**PUBLIC SERVICE COMPANY OF COLORADO**

July 25, 1984  
Fort St. Vrain  
Unit No. 1  
P-84230

SUBJECT: Fort St. Vrain Building 10

REFERENCE: NRC Letter Dated June 25, 1984  
from Mr. J. T. Collins to  
Mr. O.R. Lee (G-84208)

Figure 1

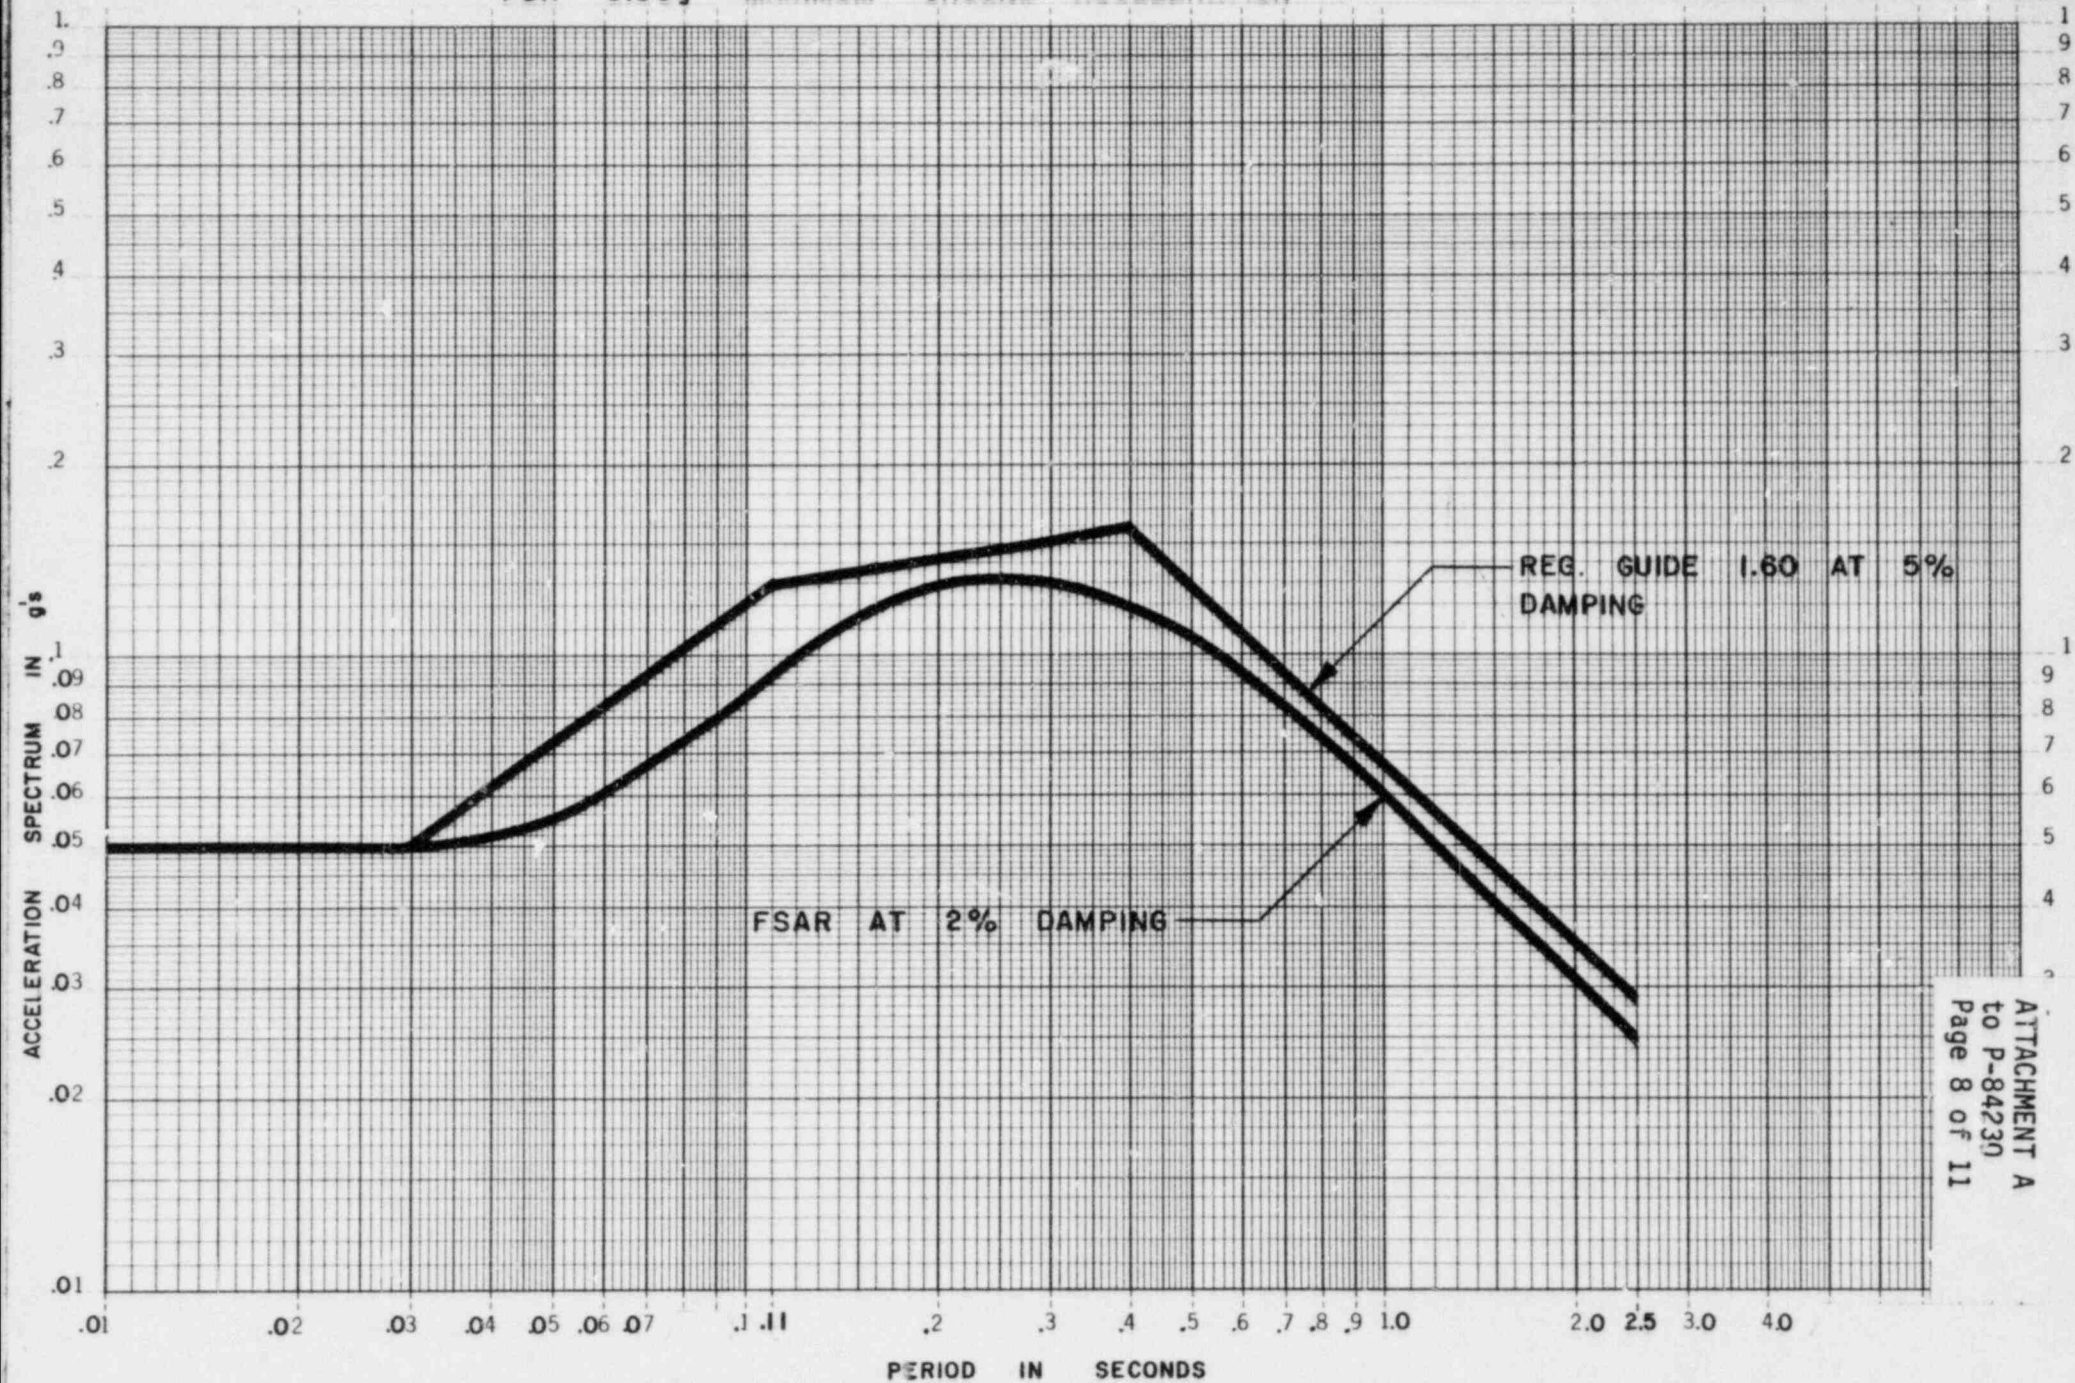
STRUCTURAL			
ITEM	BUILDING 10 AND WALKOVER STRUCTURE DESIGN CRITERIA	ORIGINAL PLANT DESIGN CRITERIA	REMARKS
SEISMIC	Acceleration response spectra based on Reg. Guide 1.60. Maximum horizontal component of ground acceleration equal to 0.05g for OBE, 0.10g for DBE; ratio of vertical component to horizontal component varies from 2/3 to 1. Damping values per Reg. Guide 1.61.	Acceleration response spectra based on records of four actual earthquake events. (Fig. 14.1-1 of FSV FSAR). Maximum horizontal component of ground acceleration equal to 0.05g for OBE, 0.10g for DBE; ratio of vertical component to horizontal component equal to 2/3. Damping values per Table 14.1-2 of FSAR.	Reg. Guides 1.60 & 1.61 provide for a more conservative criteria. Reg. Guide earthquake spectra envelope FSAR earthquake spectra. (See Figures 1 and 2 on pages 8 and 9 of Attachment A for design ground acceleration response spectra comparisons).
